Front St Underground (UG) Infrastructure T3 Upgrade
Project #1927
Request for Bid (RFB)

ADDENDUM V
Questions and Answers

DUCT BANK GRADE BEAM

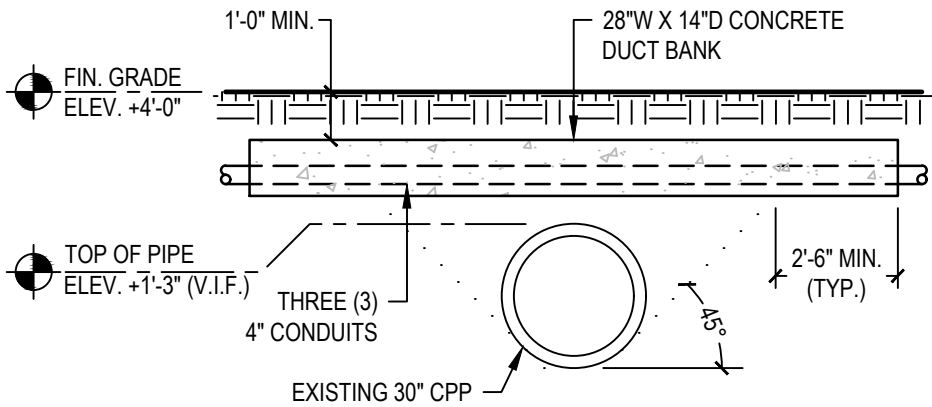
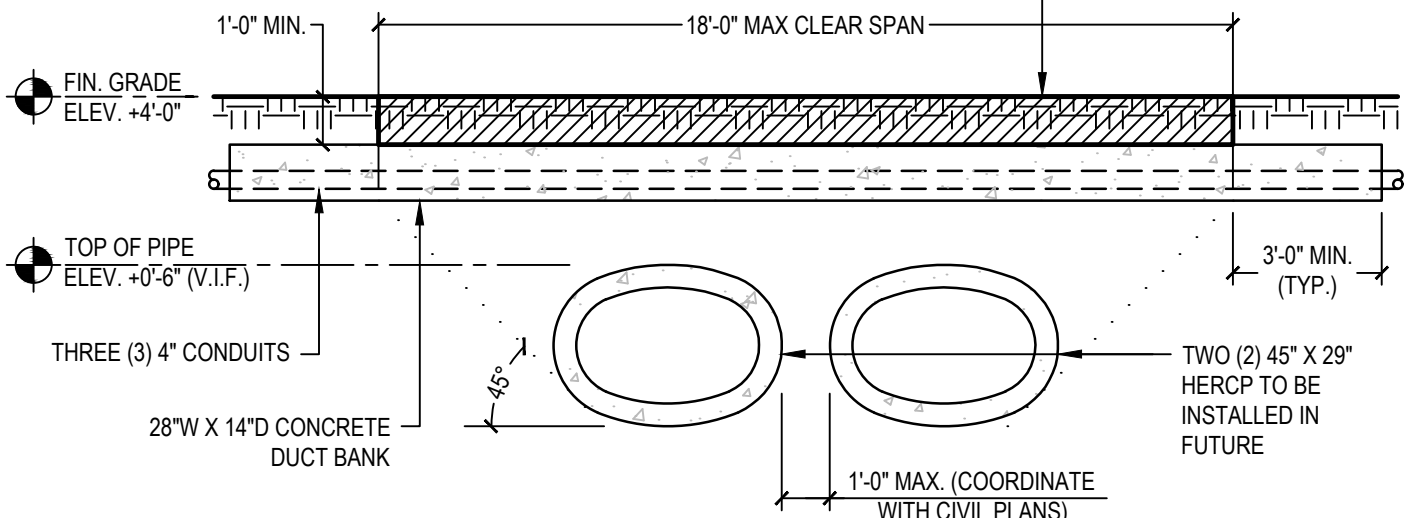
Q: There is a large drain in Constitution Park. Should the conduits go over or under the drain?

A: The electrical conduit between junction boxes JBCP and JBT3 will need to be hand/machine dug instead of directional bore. The conduits should be concrete encased where they cross the existing storm drain lines and where they will cross the future storm drain lines. See attached duct bank grade beam sketch document for encasement details.

- DESIGN CONSIDERATIONS:**
1. MAXIMUM DEFLECTION RATIO OF L/360.
 2. MIN. CONCRETE COMPRESSIVE STRENGTH 4,000 PSI
 3. ALLOWABLE SOIL BEARING PRESSURE 1,500 PSF
 4. GR. 60 STEEL REINFORCEMENT
 5. NORMAL WEIGHT CONCRETE
 6. **FUTURE HERCP PIPE SHALL NOT BE INSTALLED WITHOUT FIRST REMOVING SOIL AND SLAB OVERBURDEN ABOVE INSTALLED DUCT BANK.**

REMOVE OVERBURDEN BEFORE EXCAVATING FOR NEW HERCP INSTALLATION.
